DATE: November 4, 2020

<u>Certificate of Appropriateness Request:</u>	H-30-20
<u>Applicant:</u>	Locke Mill Plaza, Elizabeth Bean
<u>Location of subject property:</u>	1 Buffalo Ave. NW
<u>Staff Report prepared by:</u>	Katherine Godwin, Sr. Planner

- Applicant is requesting to:
 - Install a keypad operated, automatic barrier gate to the entrance of the rear parking lot (ex post facto)
 - Install 4 brick pillars to limit vehicular access to the entrance of the rear parking lot
 - Install an automatic barrier gate to the exit of the rear parking lot (ex post facto)
 - Install 1 brick pillar to limit vehicular access to the exit of the rear parking lot (Exhibits B, D, and E).

Exhibit D

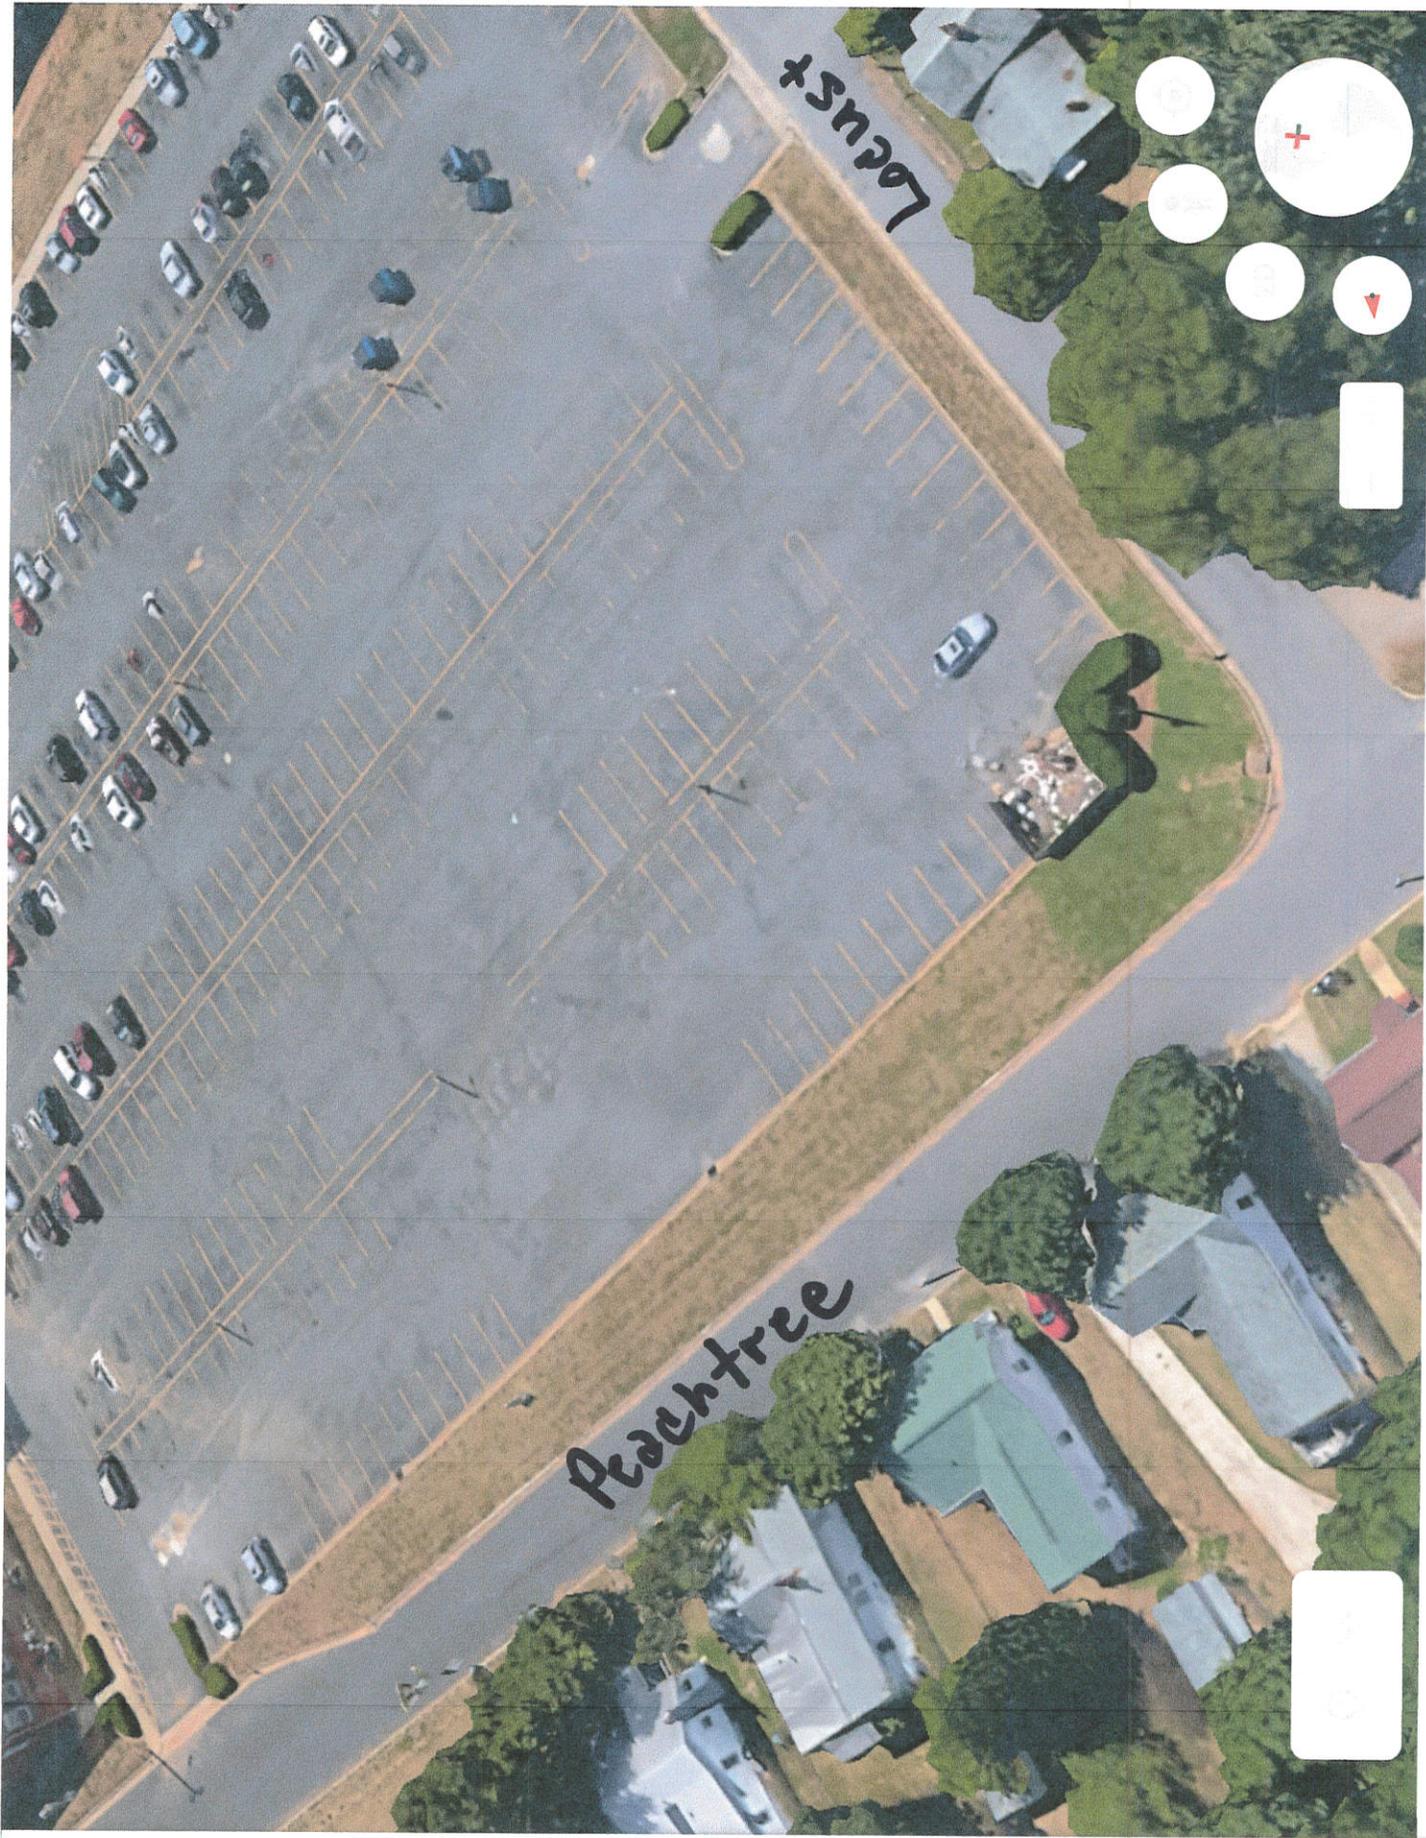
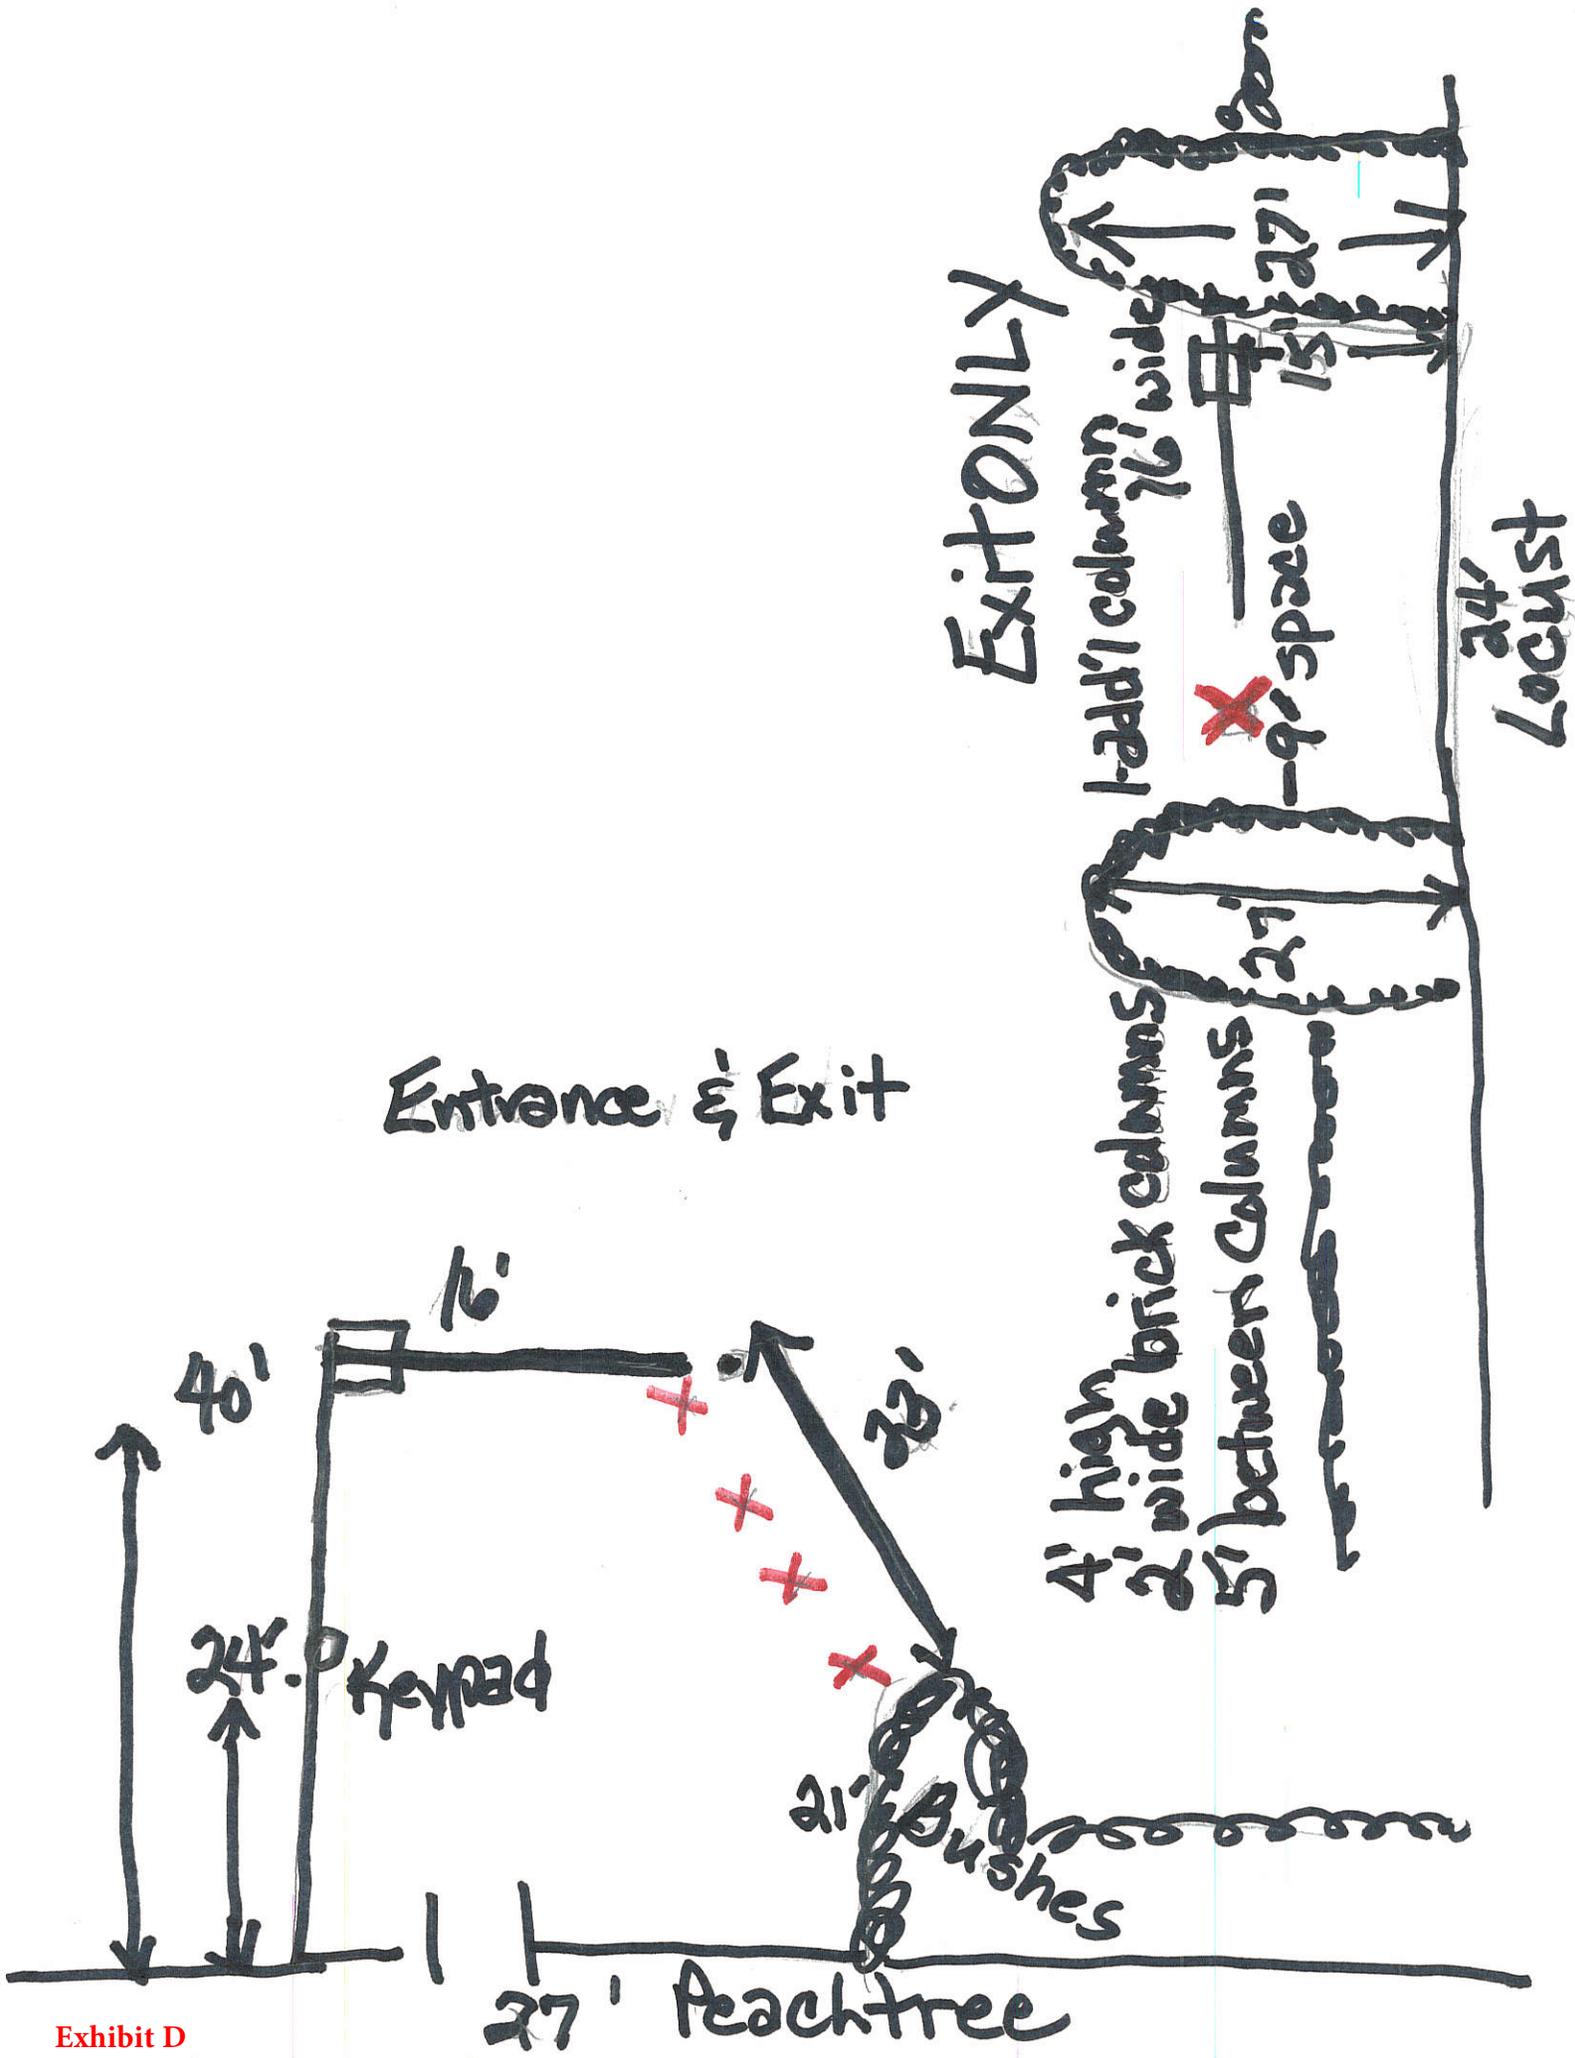
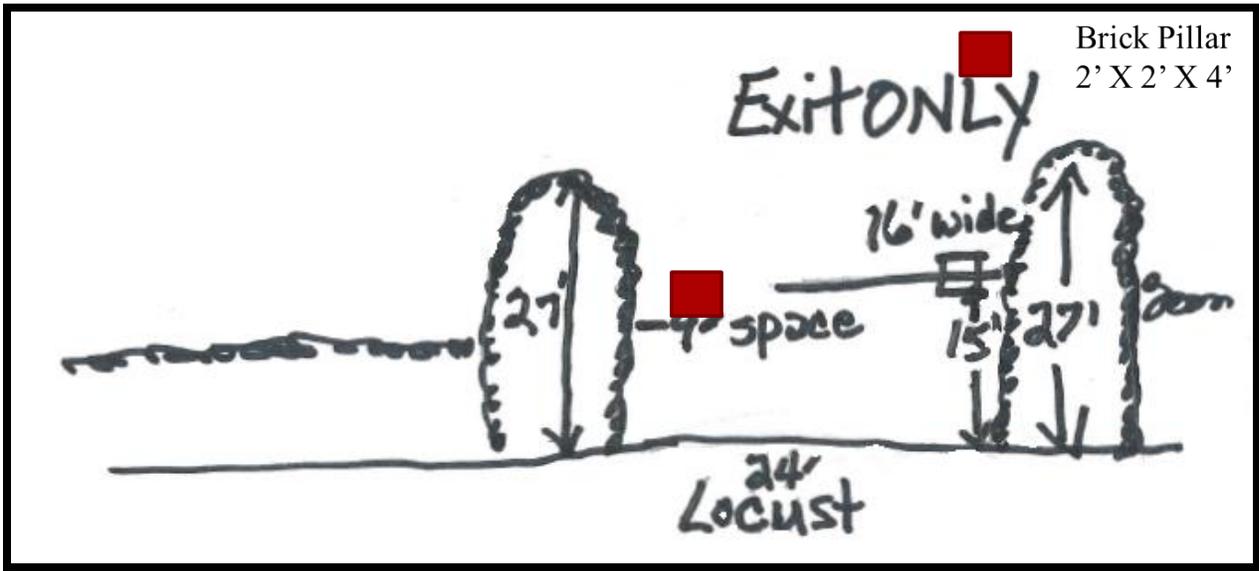
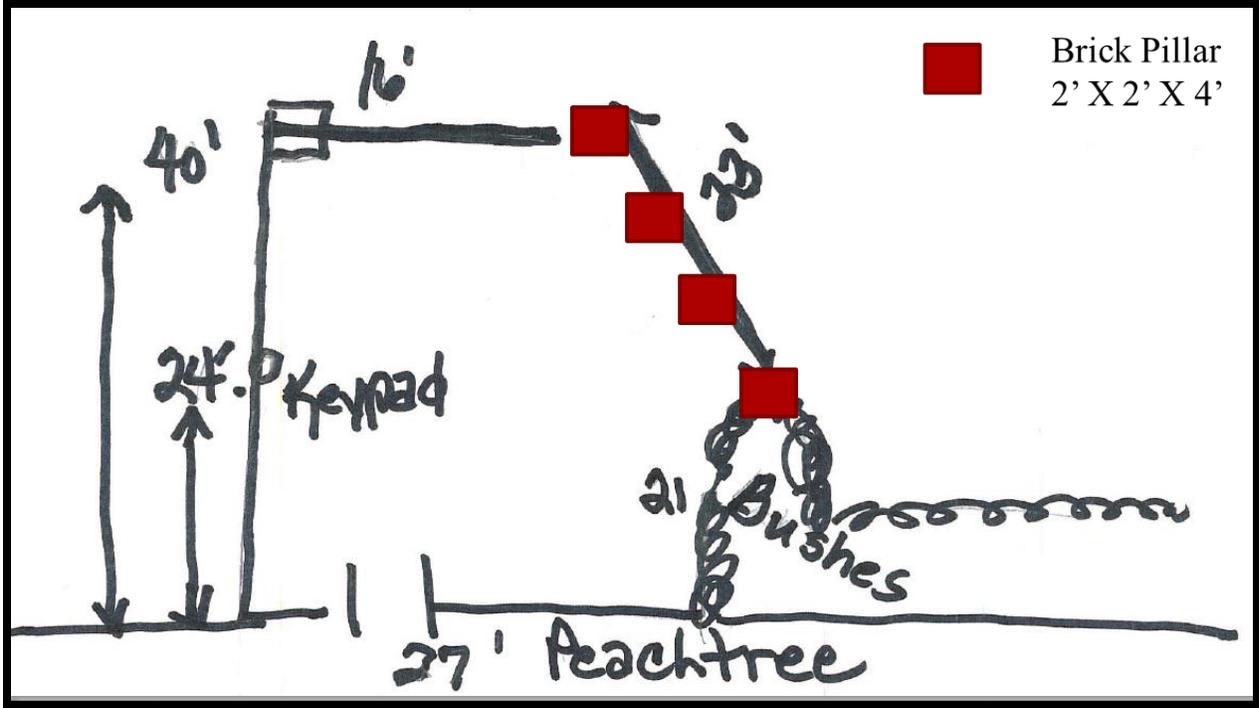
Due to the width of the entrance and exit, vehicles can still bypass the barrier gate (Exhibits D and E). To address this issue, the applicant has installed temporary wooden posts, traffic cones, and metal sign posts to block traffic (Exhibit E). The applicant is proposing to install five (5) brick pillars measuring 2' wide by 2' long and 4' high (Exhibits B, D, and E). Four (4) of the pillars would be installed at the entrance off of Peachtree Ave NW and one (1) pillar would be installed at the exit on Locust St. NW (Exhibit D). The brick would closely match the brick of the building (Exhibits B, E, and F).

- You are good with switching the entrance/exit off of Peachtree to just entrance correct? **Correct**
- You are okay with aligning the brick columns with where there are currently the wooden post and traffic cones or the sign with the understanding that the reflector and any signs will then be attached to the brick column? **Correct**
